CALIFORNIA COASTAL COMMISSION

Item Tu 14a**STAFF REPORT: REVISED FINDINGS**

APPLICATION NUMBER: 5-00-449

PROJECT DESCRIPTION: Improvements to the Lido Isle entryway, including construction of a new street median, a new traffic island, a new public park, revised parking configuration and associated landscape and hardscape improvements.

COASTAL COMMISS
5-00-4
 EXHIBIT # 3
 PAGE 1 OF 1

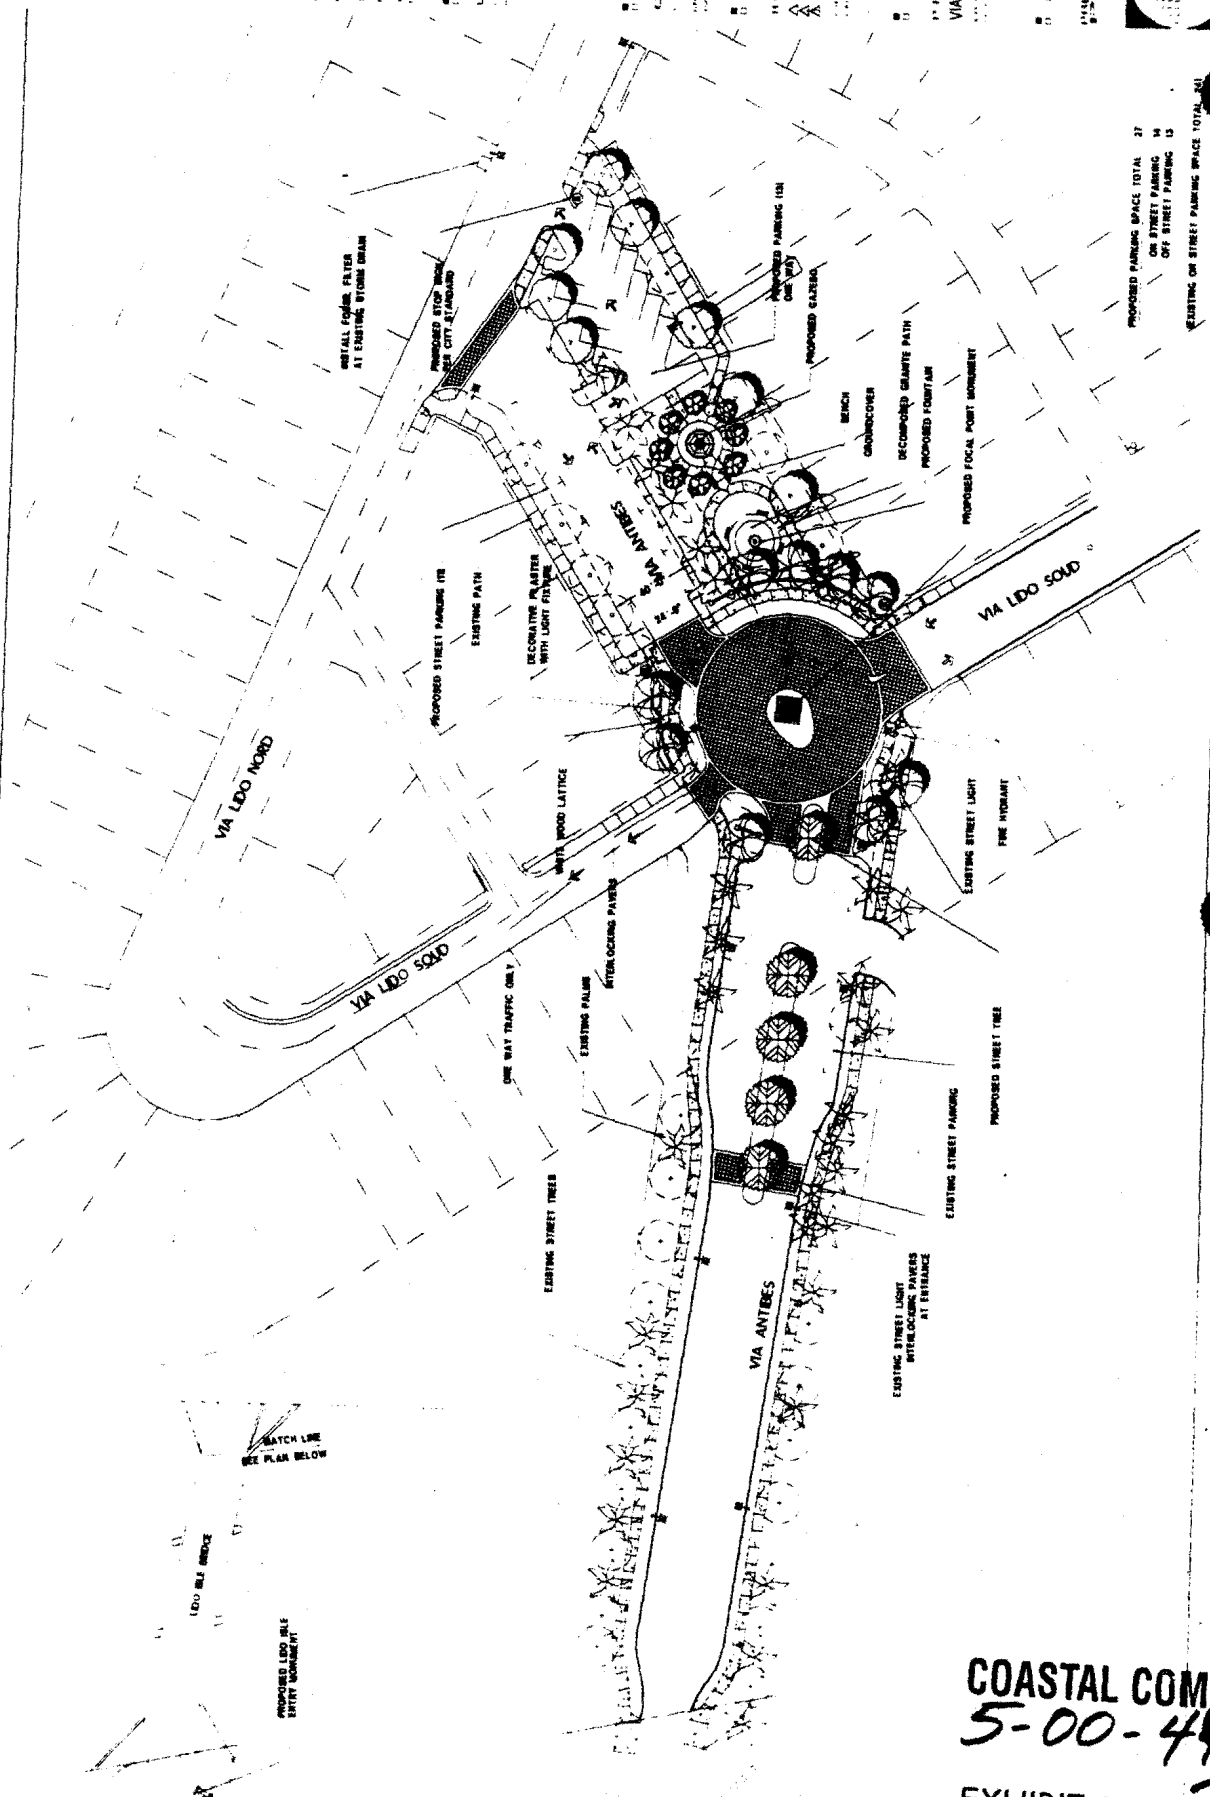
As described previously, the Lido Isle HOA is proposing improvements to the entryway of an island used solely for residential use. The applicant submitted plans with "monuments" proposed at two (2) locations—a "Focal Point Monument" at the center of the proposed traffic island and a "Lido Isle Entry Monument" at the entrance to the Lido Isle Bridge (Exhibit 3).

Preliminary elevation drawings of the "Focal Point Monument" showed an approximately 30' high Cape Code-style lighthouse with Lido Isle identification signage and a community events board. Members of the public have expressed concern regarding the potential "guard house" appearance of the proposed structure. As architectural features and signage can affect the public's perception of access opportunities at a location—particularly a residential island with no perceived visitor-serving development—the design of any proposed monuments and/or signage at the Lido Isle entryway is significant. Imposing, monumental scale architectural features may give the appearance of privatization and deter members of the public from entering the island. The applicant states that the monument at the center of the traffic roundabout was never intended to function as a "guard house" or give the appearance of a "guard house." Nevertheless, the applicant states that the "Focal Point Monument" will be removed from the proposed project design due to traffic engineering concerns. (Traffic, Circulation and Parking will be discussed further in Section C).

As described previously, the applicant is proposing modifications to the current traffic pattern at the Lido Isle entryway. A major component of the plan involves the installation of a traffic roundabout and the closure of an existing travel lane (Exhibit 3). The applicant has submitted a report prepared by Linscott, Law & Greenspan entitled *Existing Traffic Conditions Summary and Preliminary Design Review for the Lido Isle Entry Improvement Project*. The report summarizes existing traffic patterns and analyzes the proposed project, including the creation of a new traffic island, or traffic roundabout. As described in the report, "roundabouts are typically associated with a menu of 'traffic calming' techniques, which have the objectives of addressing traffic issues while improving aesthetics and neighborhood quality of life."

The project will provide 14 on-street parking spaces and thirteen (13) off-street parking spaces in the newly created lot, for a total of twenty-seven (27) spaces. At present, there are twenty-four (24) on-street parking spaces (Exhibit 4). Although the project will result in a loss of on-street parking, there will be a net gain of three (3) parking spaces through creation of the off-street

COASTAL COMMISSION
5-00-449
EXHIBIT # 4
PAGE 1 OF 1

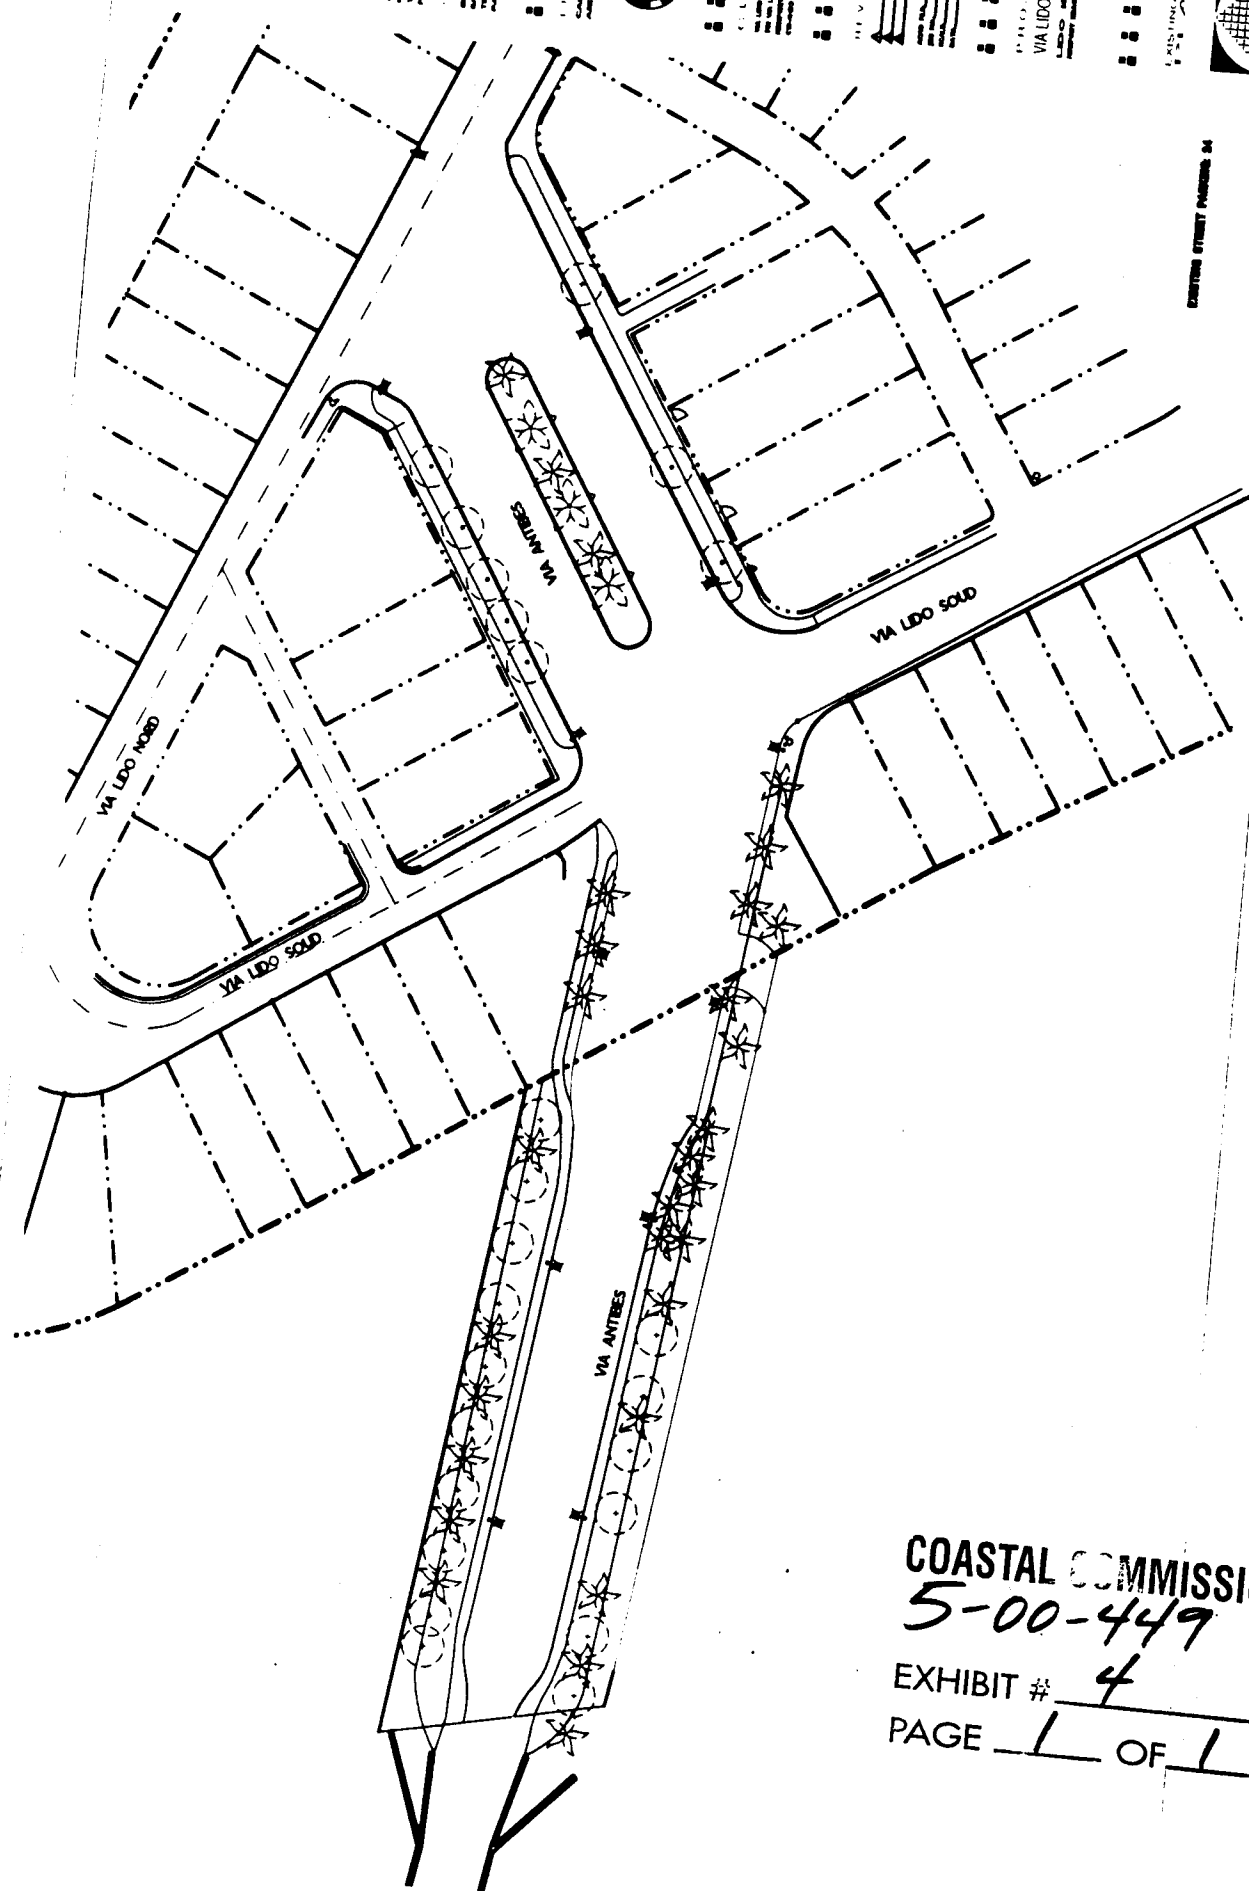
parking lot. However, the parking lot will not be immediately visible when entering the island. Instead the lot will be located directly adjacent to residential development and screened by vegetation. Tenants of the residential units will most likely take advantage of the newly created off-street parking. As such, visitors to the island will not be aware that they can park their vehicles within the lot while visiting the nearby street end beaches.

EXHIBIT # 6

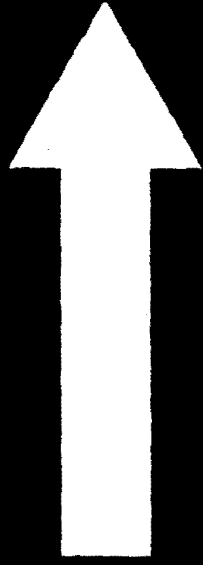
No public visitor-serving commercial or recreational development exists on Lido Isle. Nonetheless, the island presents opportunities for both visual and physical public access to the water via various street ends open areas. The public may traverse private community-maintained pocket parks via 4' wide public access easements in order to reach the water's edge (Exhibit 5). Pursuant to CDP 5-82-218, signage is required to inform visitors that vertical public access is allowed through each of these parks. Recently, the Lido Isle Community Association submitted a signage plan in conformance with the requirements of that permit. Existing signage, which suggests the parks are entirely private, will be replaced with the sign example shown in Exhibit 6.
